## COA-0008-2020

### 1014 DOROTHEA DR

Nature of Project:  
Construct addition; alter windows

APPLICATION FOR A CERTIFICATE OF APPROPRIATENESS – STAFF REPORT

**B**  
 NEW NORTH ELEVATION

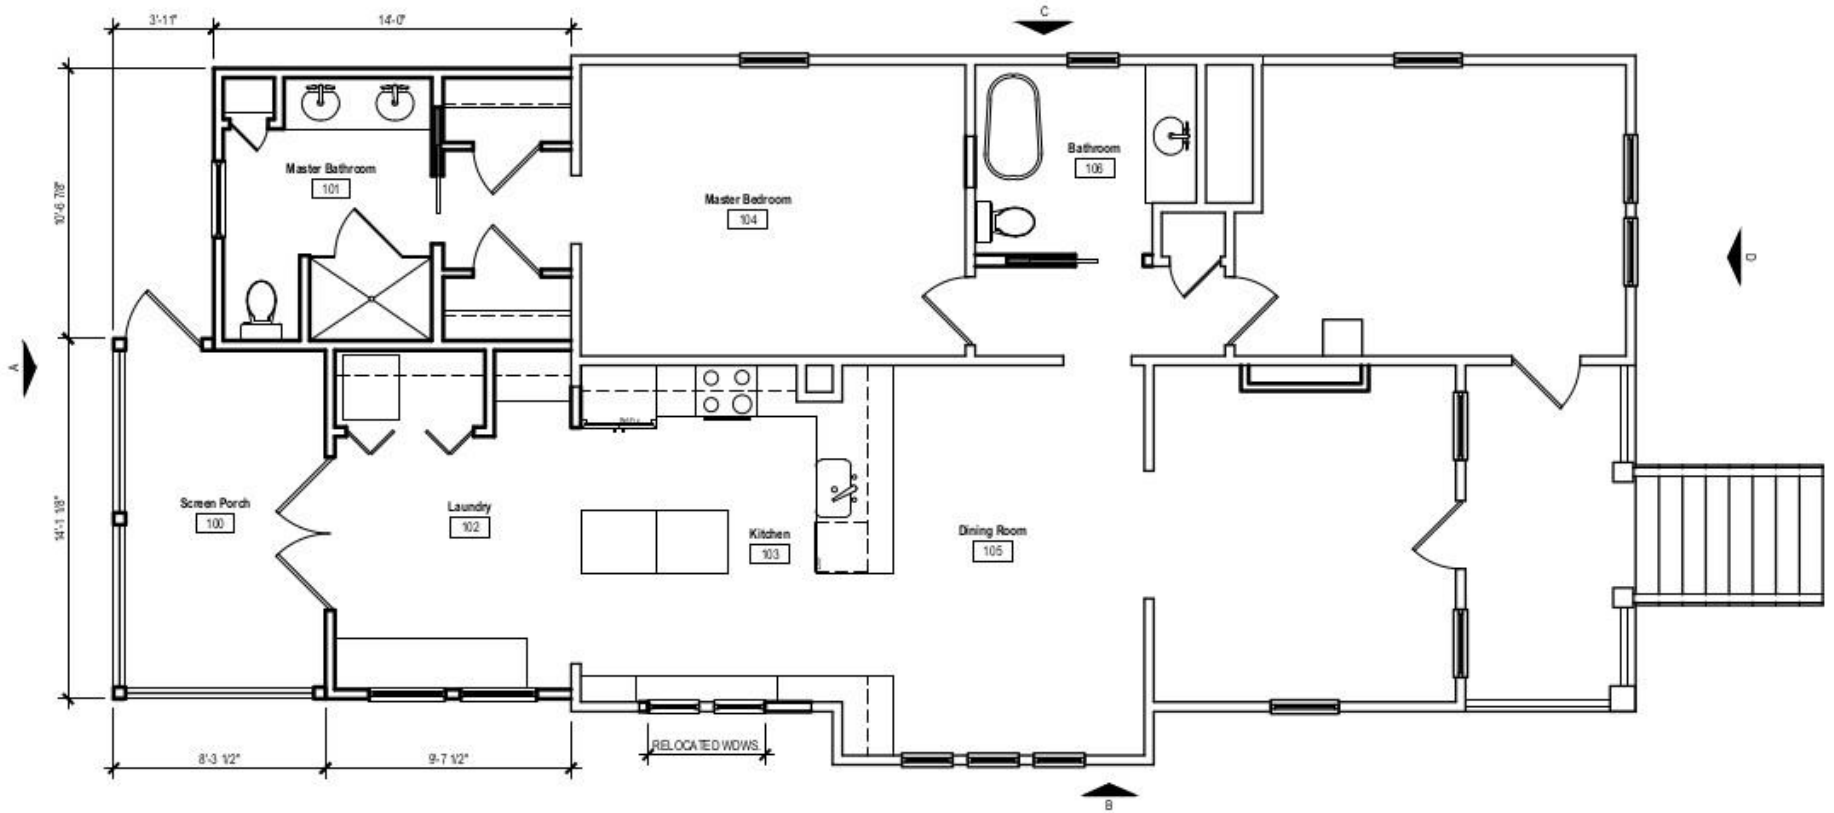
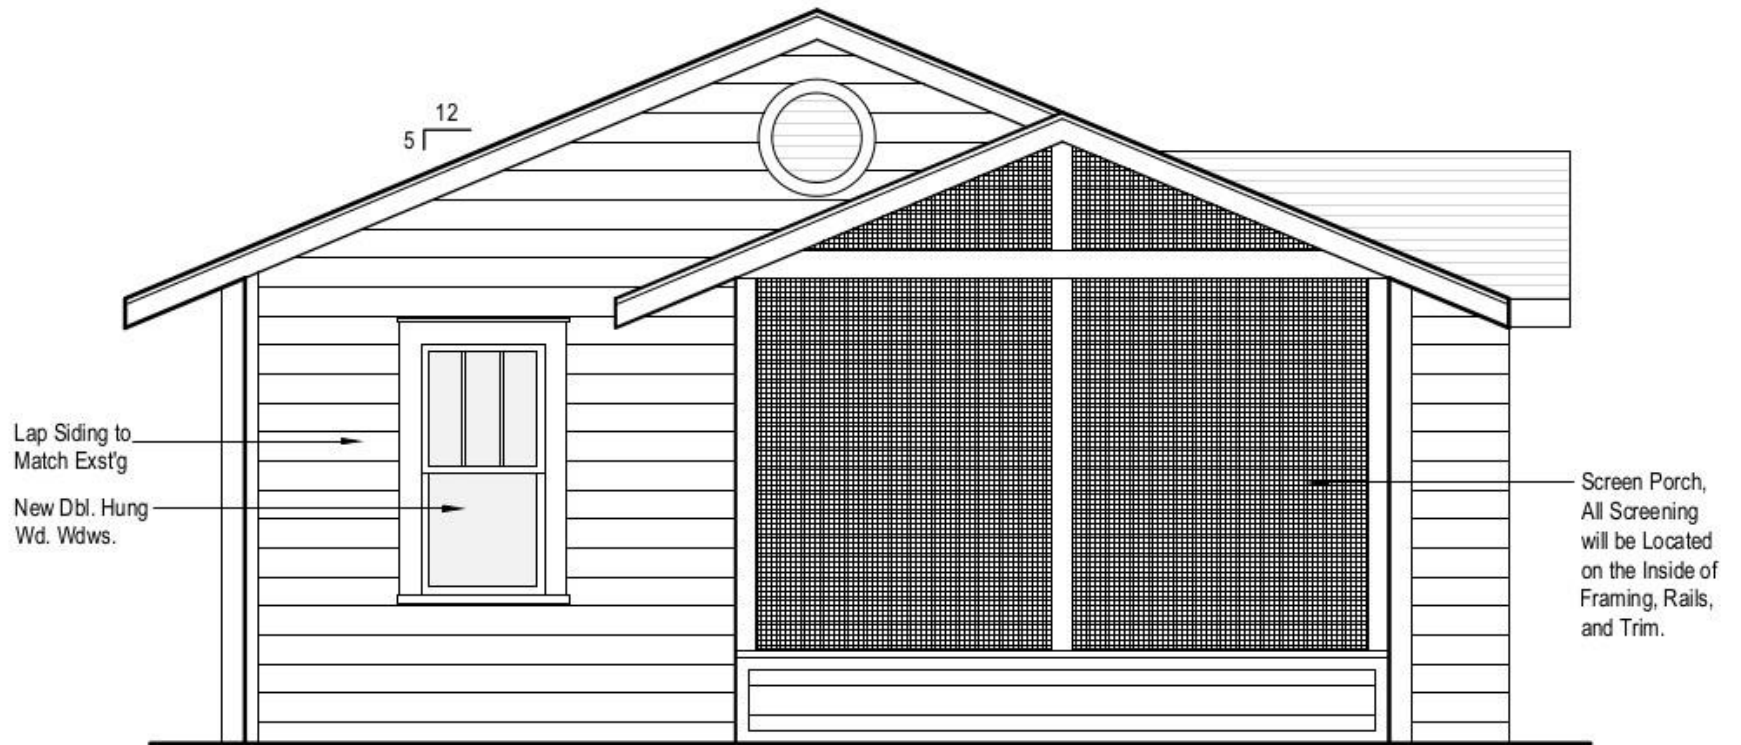
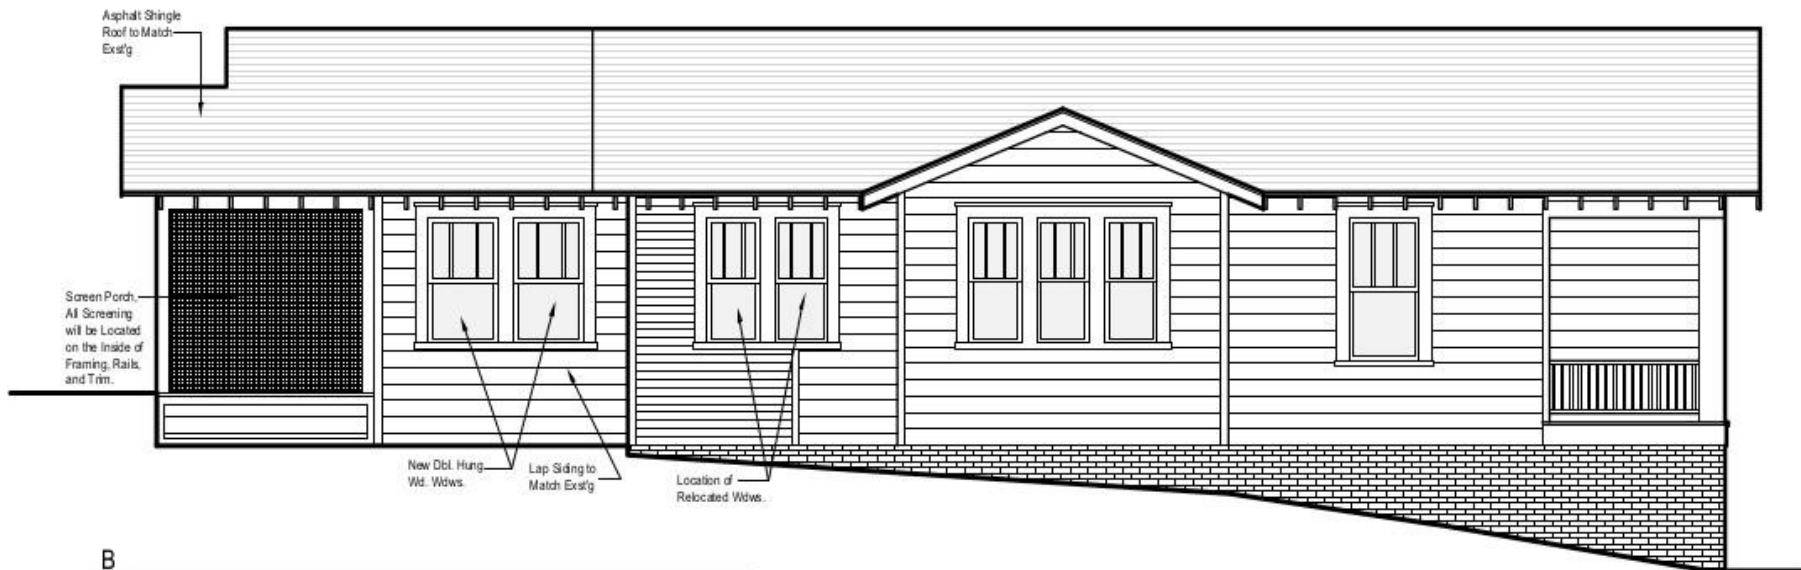
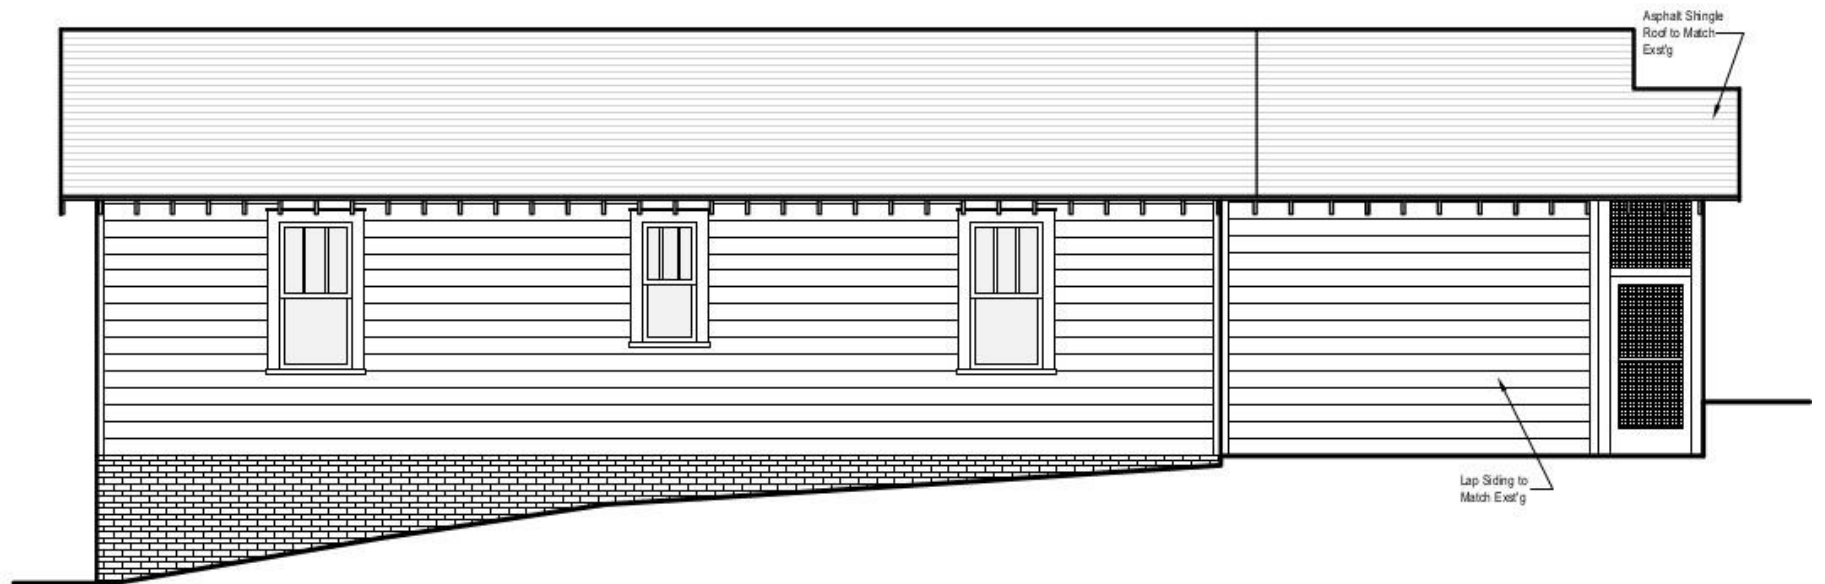
- 6\* The windows on the addition are drawn to show flat trim on three sides and a sill on the bottom as is traditional. Window specifications for the 3-over-1 windows were not provided.

- 8\* The north west corner of the addition includes a screened porch. A note on the elevation drawings states that the screening for the porch is to be on the inside of the framing and rails as has been found to be congruous for other screened porches in Boylan Heights.

1. That a tree protection plan be implemented and remain in place for the duration of construction.
2. That details and specifications for the following be provided to and approved by staff prior to issuance of the blue placard:
  - a. Eave/soffit details;
  - b. Window specifications including sections and muntin profiles
  - c. A site plan noting the locations and critical root zones of trees greater than 8" DBH on this property as well as the critical root zones from trees on adjacent properties.
  - d. An illustrated tree protection plan prepared by an ISA certified arborist that addresses the critical root zones and provides staging areas for construction materials.
3. That details and specifications for the following be provided to and approved by staff prior to installation or construction:
  - a. HVAC dimensions and associated screening.

Site Plan

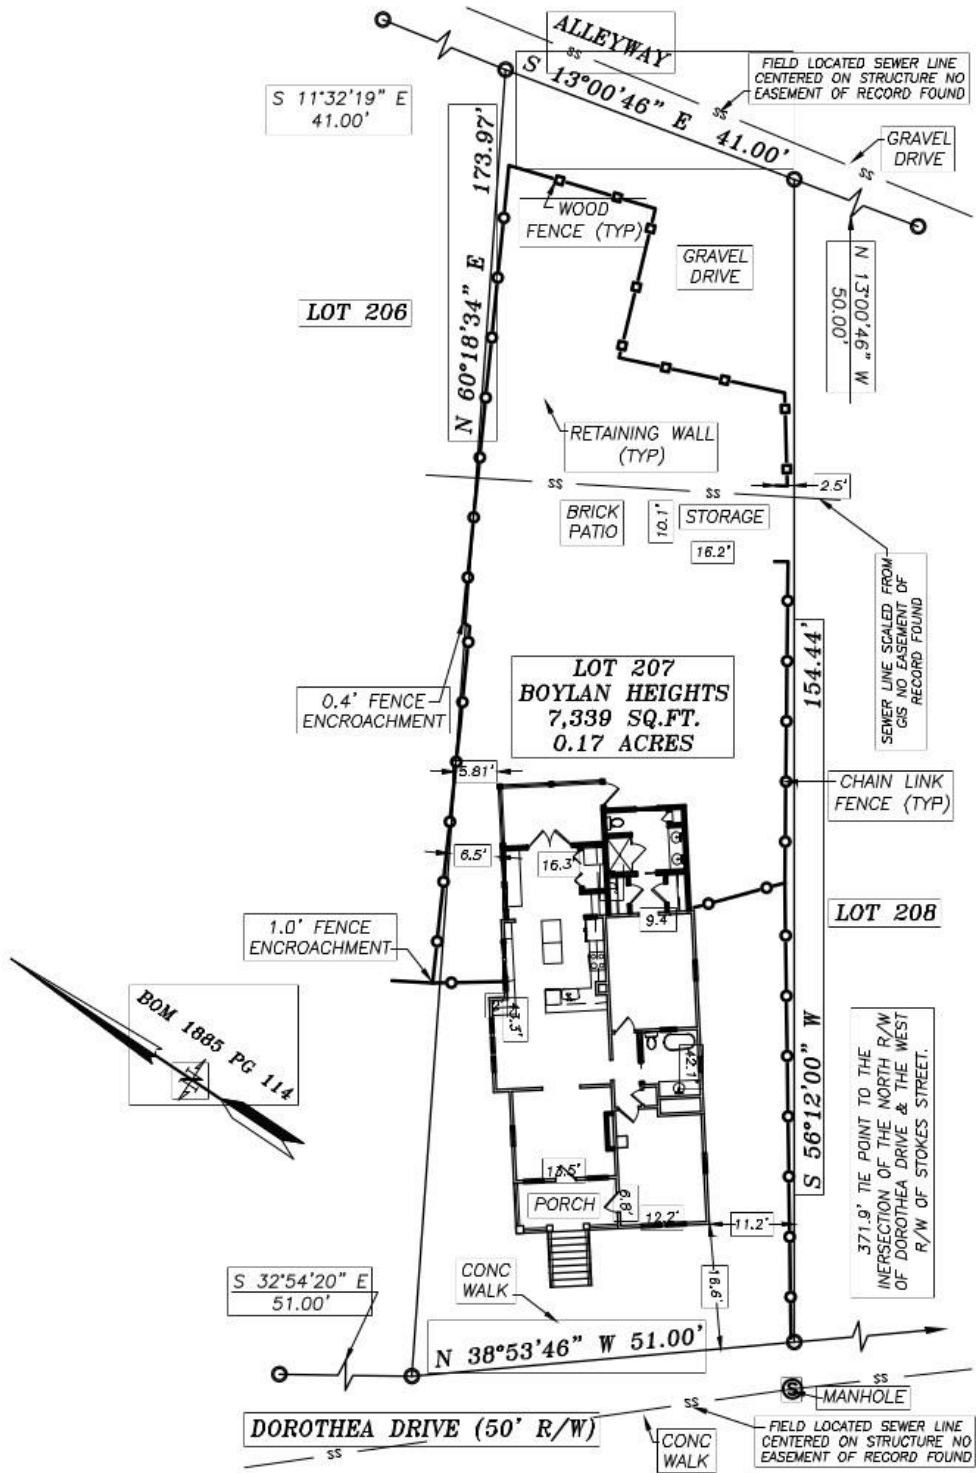
- 12\* The application includes a statement from an arborist certified by the International Society of Arboriculture (ISA) that includes instructions as to how tree protection could be implemented, but does not include a tree protection plan or a drawing noting the locations of identified trees.

- 13\* A plan identifying trees on the subject property and the root zones of trees on adjacent properties was not provided
- B. Altering windows is not incongruous in concept according to *Guidelines 2.6.8, 2.7.2, 2.7.11*, and the following suggested facts:
